IMPROVING THE OPERATION OF THE SCELB1-8H STEP SWITCH

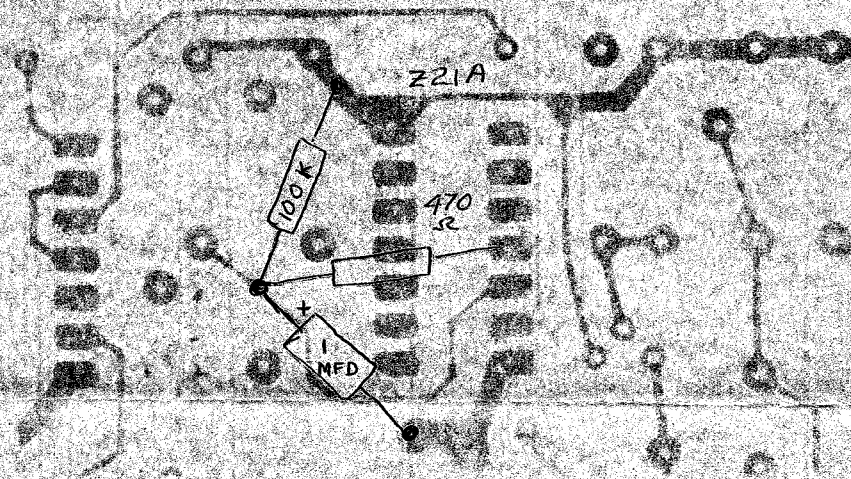
- 1.) CIRCUIT MODIFICATION TO THE CPU CARD STEP CIRCUITRY AT I.C. 221A. CHANGE THE CIRCUITRY AT 221A TO APPEAR AS SHOWN IN THE SCHEMATIC BELOW.

THE CHANGE CONSIST OF ADDING TWO RESISTORS (CA 470 OHM AND A 100,000 OHM $1/4$ WATT) PLUS A 1 MFD CAPACITOR AT 221A AS ILLUSTRATED IN THE SCHEMATIC. THE ADDITION OF THE COMPONENTS CAN BEST BE IMPLEMENTED BY MOUNTING THE PARTS ON THE CIRCUIT SIDE OF THE CPU CARD AS SHOWN IN THE DIAGRAM ON THE NEXT PAGE. THE DIAGRAM SHOWS THE FOIL PATTERN ON THE CIRCUIT SIDE OF THE CARD IN THE VICINITY OF I.C. 221A (TOWARDS THE UPPER RIGHT HAND CORNER NEAR THE TRIMPOTS WHEN VIEWED FROM THE BACK OF THE CARD WITH THE CONNECTOR PINS EDGE OF THE CARD NEAREST THE OBSERVER). BE SURE TO CUT THE P.C. FOIL AT THE POINT NEXT TO THE FOIL PAD MARKED "A" IN THE DIAGRAM.

THE FIRST MODIFICATION ELIMINATES THE POSSIBILITY OF CONTACT BOUNCE UPON RELEASE OF THE STEP SWITCH CAUSING MULTIPLE STEP OPERATION.
